## Report Committee of Adjustment

**File:** A-2021-0234

**Address:** 14 FAIRMONT CLOSE, BRAMPTON, ON L6Y2Y3

# SITE PLAN

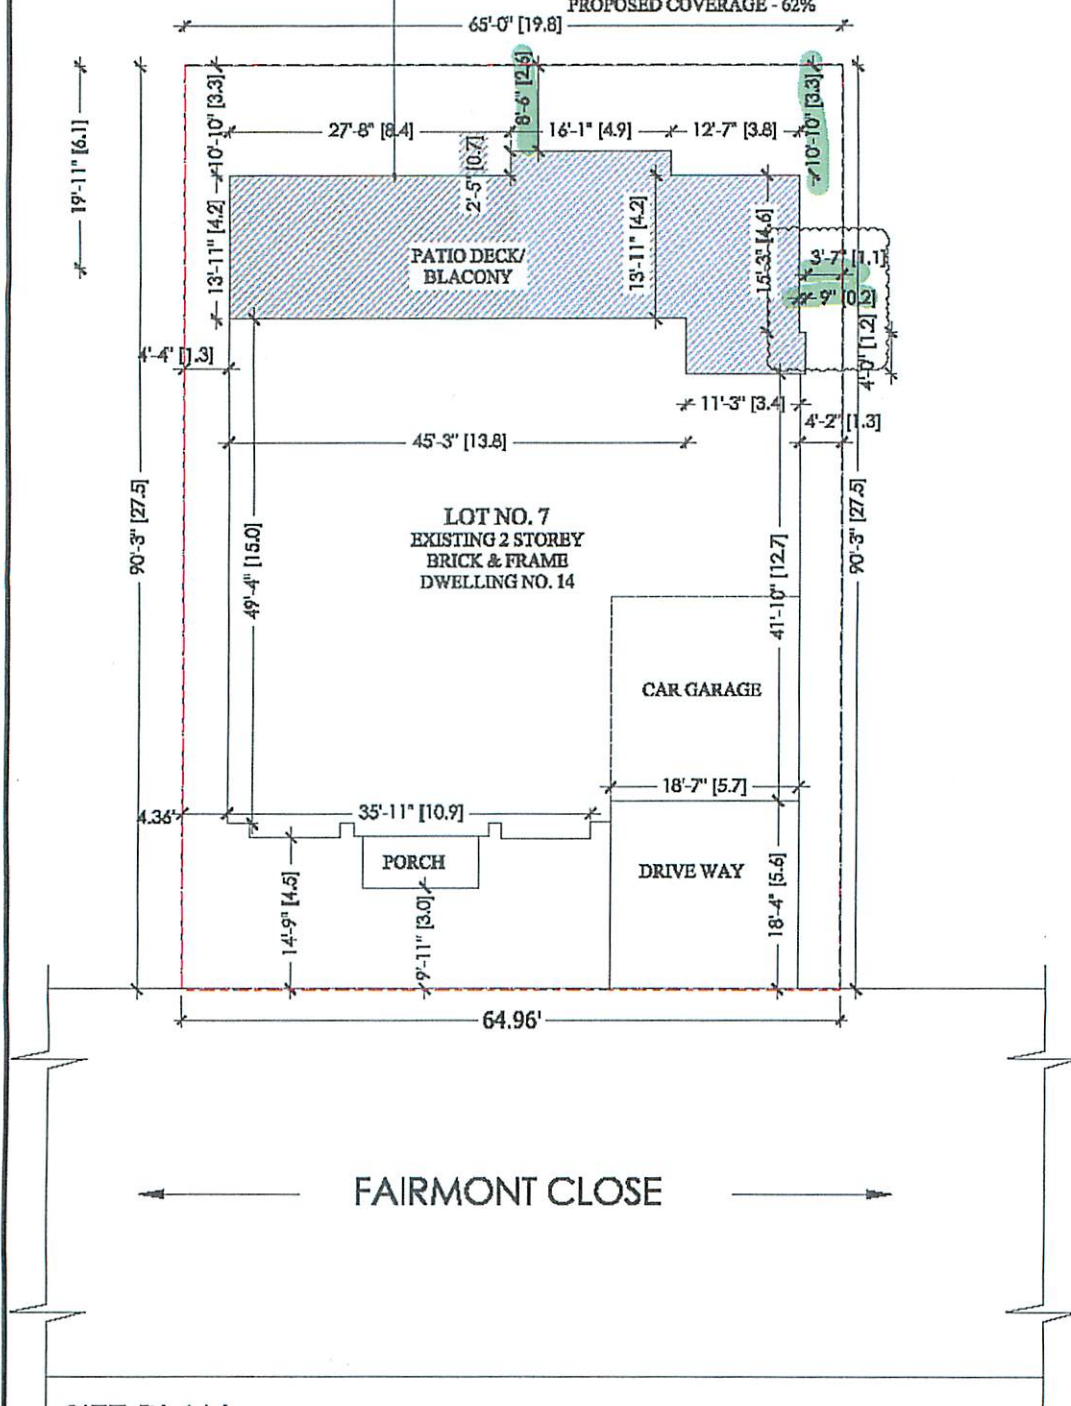
The variance is requested to permit an existing balcony having a setback of 0.5m (1.64 ft.) to the side lot line and 2.6m (8.53 ft.) to the rear lot line and occupying 100% of the width of the rear wall of the dwelling, whereas the by-law requires a minimum interior side yard setback of 1.2m (3.94 ft.) and permits a balcony having a setback of 4.5m (14.76) to the rear lot line provided that no less than 45% of the unit width is setback 7.5m (24.60 ft.). The intent of the by-law in requiring minimum setbacks and regulating the size of balconies is to ensure that the size of the balcony is appropriate relative to the dwelling and lot and configured in a manner that does not detract from the provision of outdoor amenity space or impact the privacy of adjacent properties.

The balcony currently occupies 100% of the width of the rear wall of the dwelling which represent a 55% increase from what the By-law permit. This request is considered to greatly detract from the outdoor amenity space and generates concerns over privacy of adjacent properties. Combined, these factors contribute to a balcony with significant massing. The existing condition of the balcony are not

Through a set of recommended conditions, staff suggest that the balcony be altered in a manner that proposes modest increases to what the by-law permits. As such, conditions of approval are recommended that the variance to permit a 1.1m side yard setback to the balcony shall be refused and that the variance for a reduced rear yard setback to the balcony be approved in part and that a minimum setback of 3.3m to the rear lot line shall be permitted, provided that the width of the balcony does not exceed a maximum of 50% of the width of the dwelling. These recommendations are intended to provide an opportunity for the Committee of Adjustment, if they see fit, to support the application in part, subject to the recommended conditions outlined above. The size of the balcony could be reduced in a manner that is supportable from a planning perspective and that addresses staff concerns.

The applicant is seeking variances to allow the existing configuration of a balcony which was constructed without a permit. In its current configuration, the balcony is not considered to be desirable for the appropriate development of the land as it is considered to generate negative impacts with respect to the provision of at-grade outdoor amenity space and privacy concerns.

1. That the variance to permit a 1.1m side yard setback to the balcony shall be refused.
2. That the variance for a reduced rear yard setback to the balcony be approved in part and that a minimum setback of 3.3m to the rear lot line shall be permitted, provided that the width of the balcony does not exceed a maximum of 50% of the width of the dwelling.
3. The owner shall obtain a building permit for the modified balcony within 60 days of the decision of approval or as extended by the Chief Building Official;
4. That drainage from the modified balcony shall flow onto the applicant's property and adjacent properties not be adversely impacted;
5. That failure to comply with and maintain the conditions of the Committee shall render the approval null and void.
